March 26, 1976

The Commission has issued the enclosed Amendments No. 20, 20, and 17 for Licenses No. DPR-38, DPR-47, and DPR-55, for the Oconee Nuclear Station, Units 1, 2, and 3. These amendments consist of changes to the Technical Specifications and are in response to your request dated December 1, 1975, as supplemented February 24 and 27, 1976.

OCONEE NUCLEAR STATION, UNIT 1

ATTACHMENT TO LICENSE AMENDMENTS

FIGURE 2.1-1A

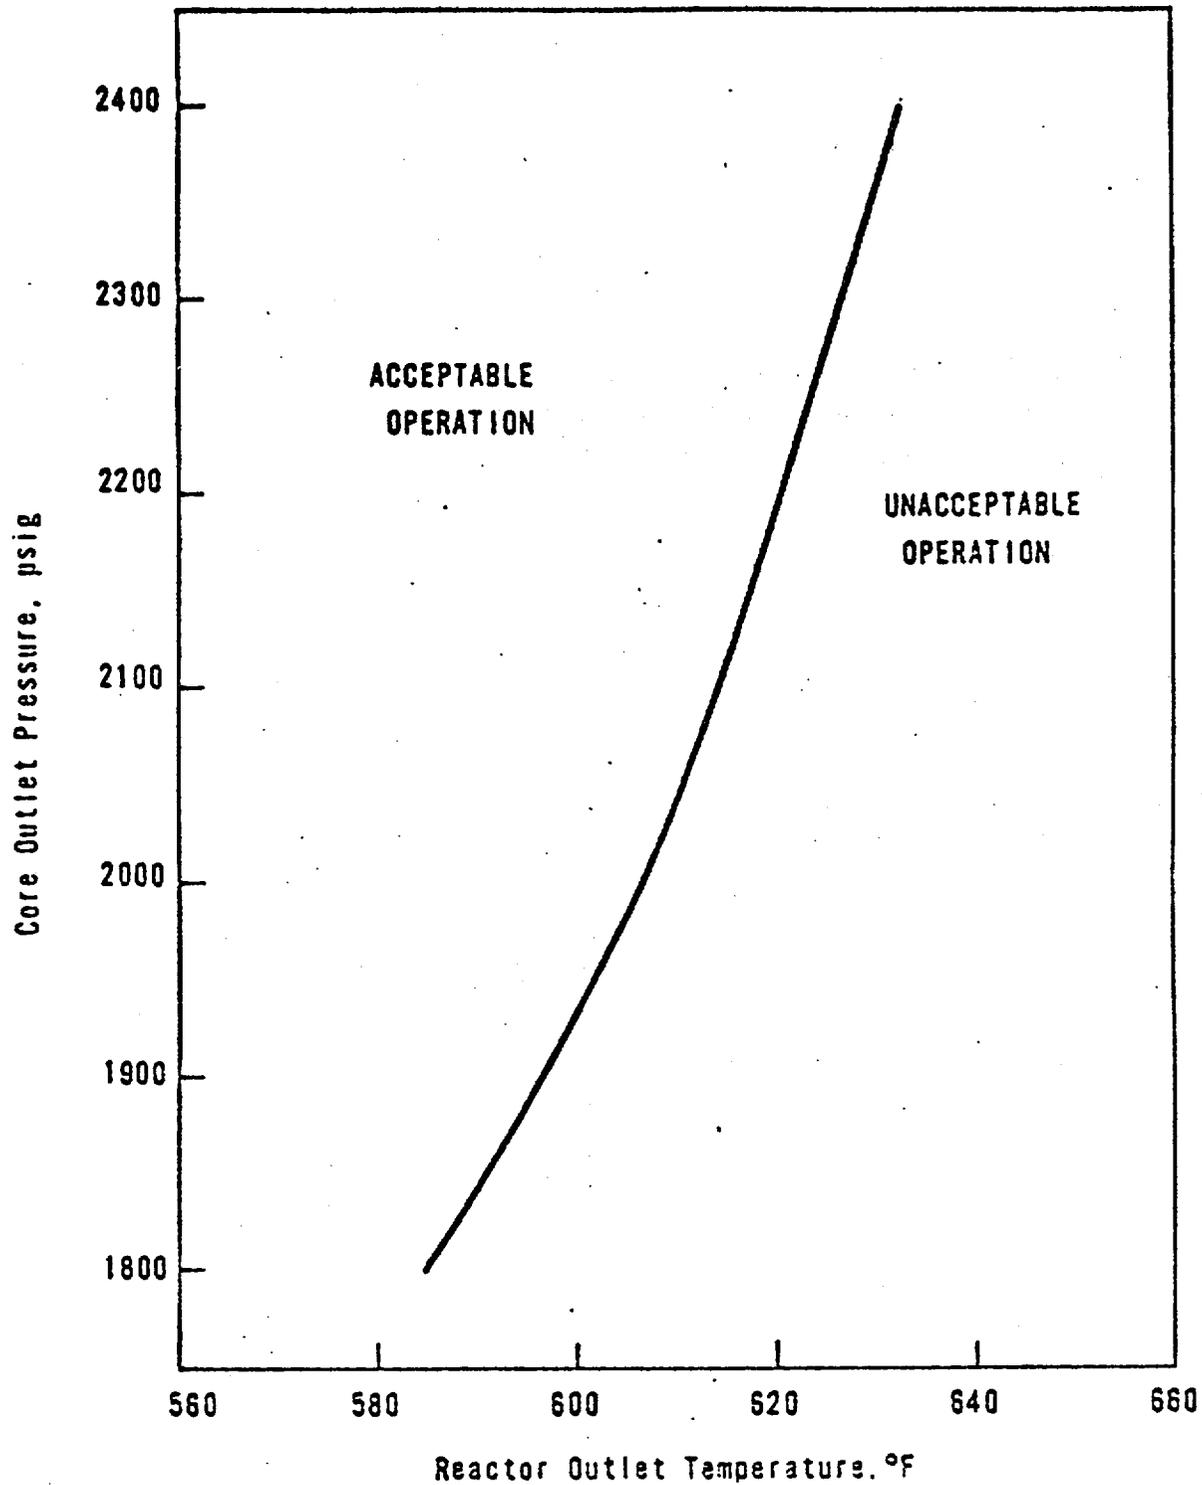
The curve presented in Figure 2.1-1A represents the conditions at which a minimum DNBR of 1.30 is predicted for the maximum possible thermal power (112 percent) when four reactor coolant pumps are operating (minimum reactor coolant flow is 107.6 percent of  $131.3 \times 10^6$  lbs/hr.). This curve is based on the combination of nuclear power peaking factors, with potential effects of fuel densification and rod bowing, which result in a more conservative DNBR than any other shape that exists during normal operation.

The curve of Figure 2.1-1A is the most restrictive of all possible reactor coolant pump-maximum thermal power combinations shown in Figure 2.1-3A.

UNIT 1  
CORE PROTECTION SAFETY LIMIT  
OCONEE NUCLEAR STATION  
FIGURE 2.1-2A

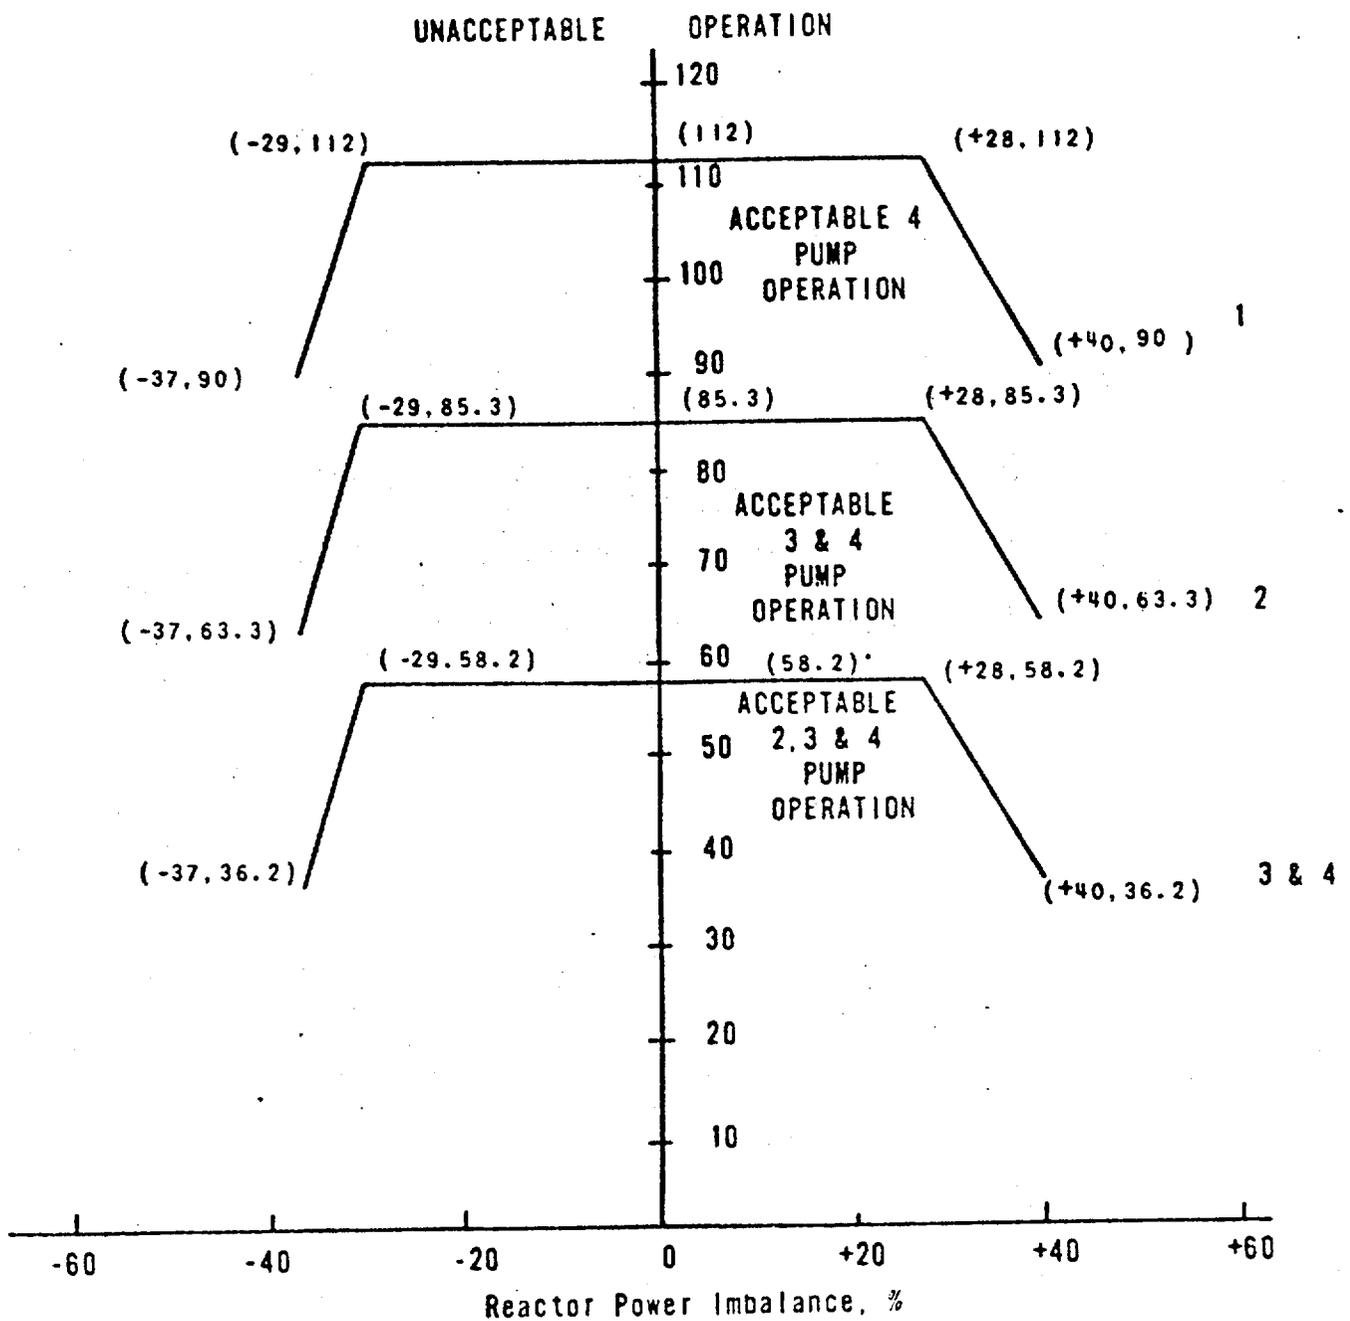
The curves of Figure 2.1-2A are based on the more restrictive of two thermal limits and include the effects of potential fuel densification and rod bowing:

1. The 1.30 DNBR limit produced by the combination of the radial peak, axial peak and position of the axial peak that yields no less than a 1.30 DNBR.
2. The combination of radial and axial peak that causes central fuel melting at the hot spot. The limit is 20.15 kw/ft for Unit 1.

The specified flow rates for Curves 1, 2, 3 and 4 of Figure 2.1-2A correspond to the expected minimum flow rates with four pumps, three pumps, one pump in each loop and two pumps in one loop, respectively.

UNIT 1  
 PROTECTIVE SYSTEM MAXIMUM  
 ALLOWABLE SET POINTS  
 OCONEE NUCLEAR STATION  
 FIGURE 2.3-1A

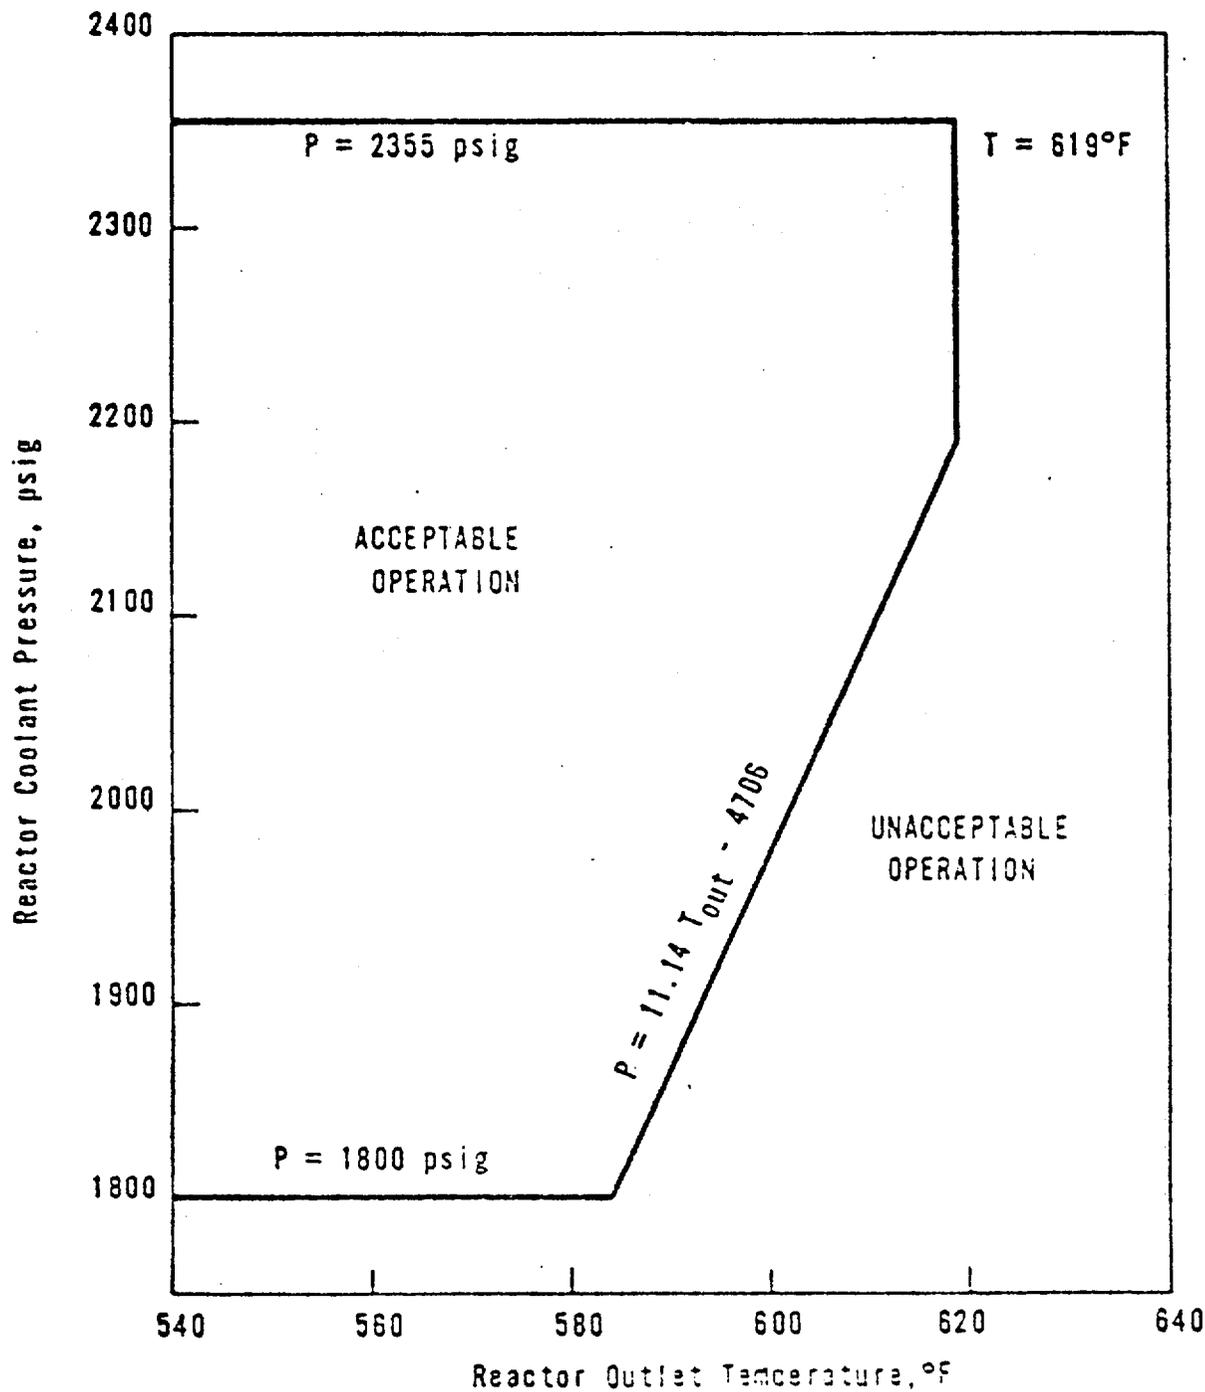
During a startup accident from low power or a slow rod withdrawal from high power, the system high pressure set point is reached before the nuclear over-power trip set point. The trip setting limit shown in Figure 2.3-1A - Unit 1

for high reactor coolant system pressure (2355 psig) has been established to maintain the system pressure below the safety limit (2750 psig) for any design transient. (1)

The low pressure (1800) psig and variable low pressure (11.14 T<sub>out</sub> -4706) trip (1800) psig (16.25 T<sub>out</sub> -7756) (1800) psig (16.25 T<sub>out</sub> -7756)

setpoints shown in Figure 2.3-1A have been established to maintain the DNBR

The high reactor coolant outlet temperature trip setting limit (619 F) shown in Figure 2.3-1A has been established to prevent excessive core coolant

UNIT 1  
PROTECTION SYSTEM MAXIMUM  
ALLOWABLE SETPOINTS  
OCONEE NUCLEAR STATION  
FIGURE 2.3-2A

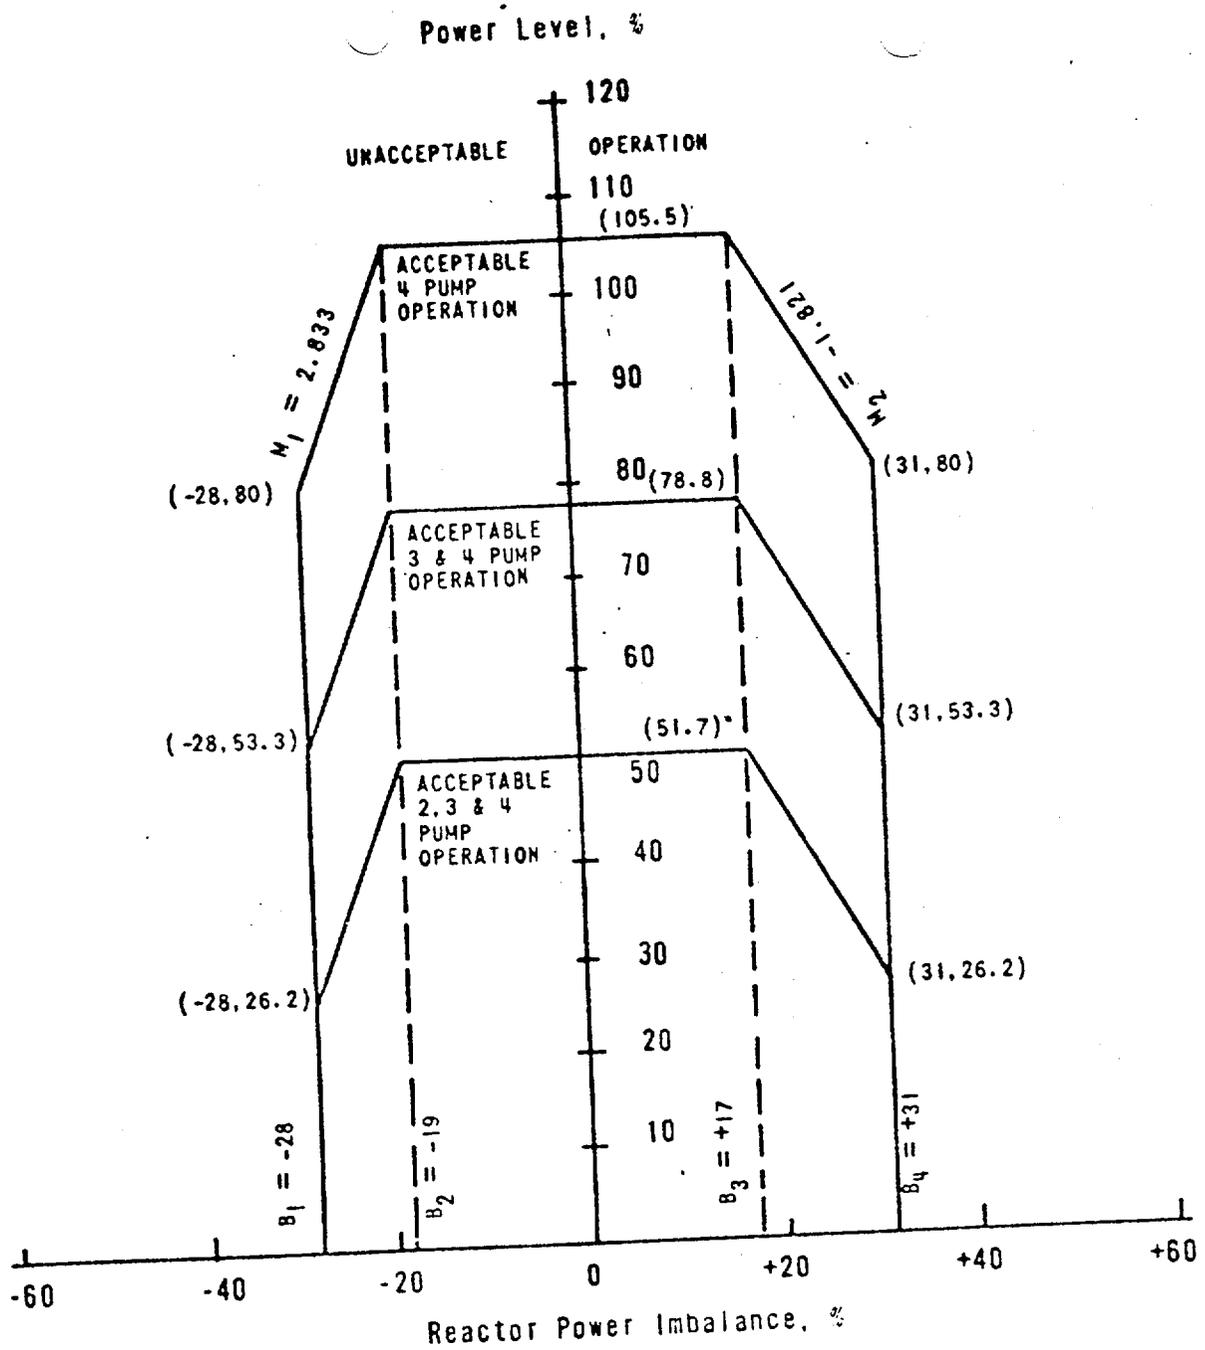
The power-imbalance boundaries are established in order to prevent reactor thermal limits from being exceeded. These thermal limits are either power peaking  $k_w/ft$  limits or DNBR limits. The reactor power imbalance (power in the top half of core minus power in the bottom half of core) reduces the power level trip produced by the power-to-flow ratio such that the boundaries of Figure 2.3-2A - Unit 1 are produced. The power-to-flow ratio reduces the power

level trip and associated reactor power/reactor power-imbalance boundaries by 1.055%-Unit 1 for a 1% flow reduction.

For Unit 1, the power-to-flow reduction ratio is 0.949, and for Units 2 and 3, the power-to-flow reduction factor is 0.961 during single loop operation.

UNIT 1  
OPERATIONAL POWER IMBALANCE  
ENVELOPE FOR OPERATION FROM  
0 TO  $230 \pm 5$  EFPD  
OCONEE NUCLEAR STATION  
FIGURE 3.5.2-3A1

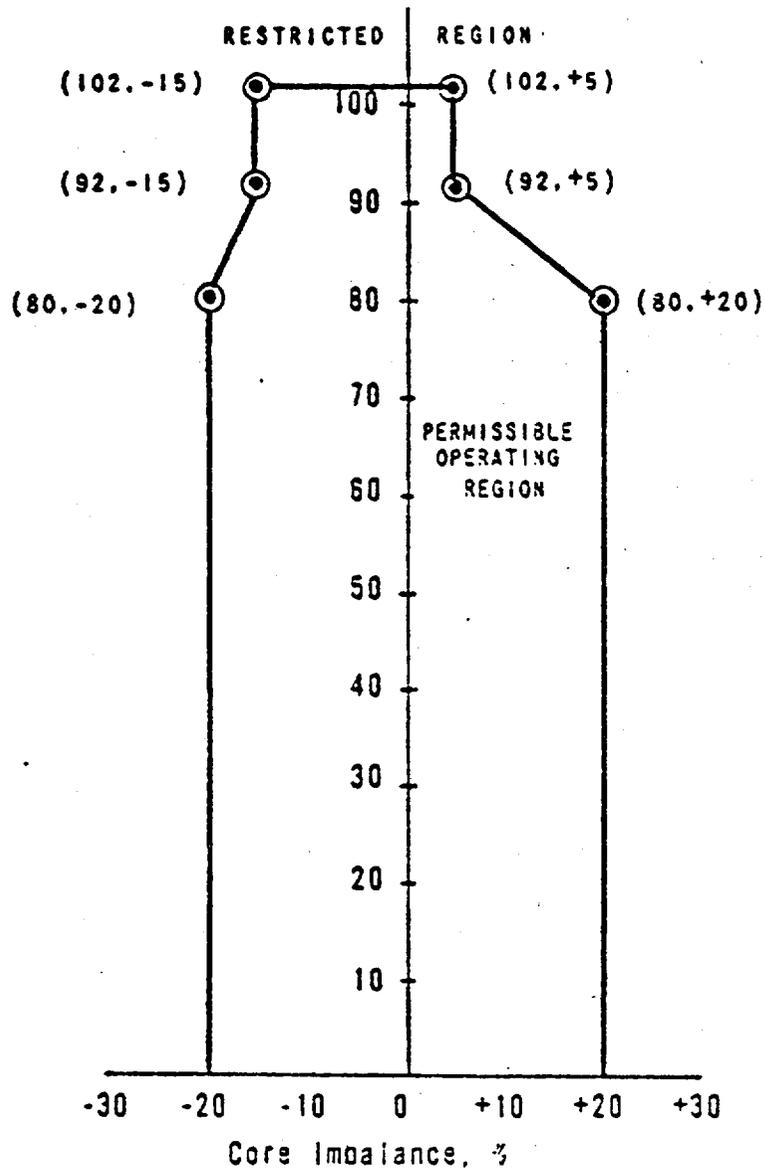
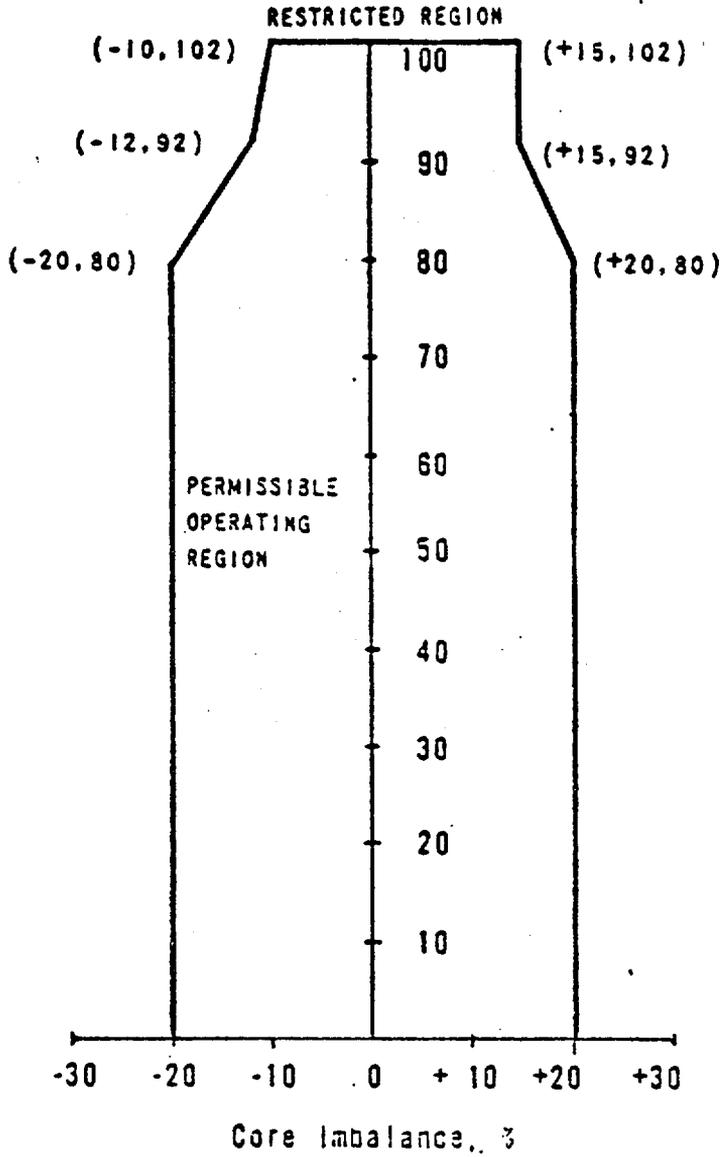
3.5.2.6 Reactor power imbalance shall be monitored on a frequency not to exceed two hours during power operation above 40 percent rated power. Except for physics tests, imbalance shall be maintained within the envelope defined by Figures 3.5.2-3A1, 3.5.2-3A2, 3.5.2-3B, and 3.5.2-3C. If the imbalance is not within the envelope defined by Figure 3.5.2-3A1, 3.5.2-3A2, 3.5.2-3B, and 3.5.2-3C, corrective measures shall be taken to achieve an acceptable imbalance. If an acceptable imbalance is not achieved within two hours, reactor power shall be reduced until imbalance limits are met.

The power-imbalance envelope defined in Figures 3.5.2-3A1, 3.5.2-3A2, 3.5.2-3B, and 3.5.2-3C is based on LOCA analyses which have defined the maximum linear heat rate (see Figure 3.5.2-4) such that the maximum clad temperature will not exceed the Final Acceptance Criteria. Corrective measures will be taken immediately should the indicated quadrant tilt, rod position, or imbalance be outside their specified boundary. Operation in a situation that would cause the Final Acceptance Criteria to be approached should a LOCA occur is highly improbable because all of the power distribution parameters (quadrant tilt, rod position, and imbalance) must be at their limits while simultaneously all other engineering and uncertainty factors are also at their limits.\*\* Conservatism is introduced by application of:
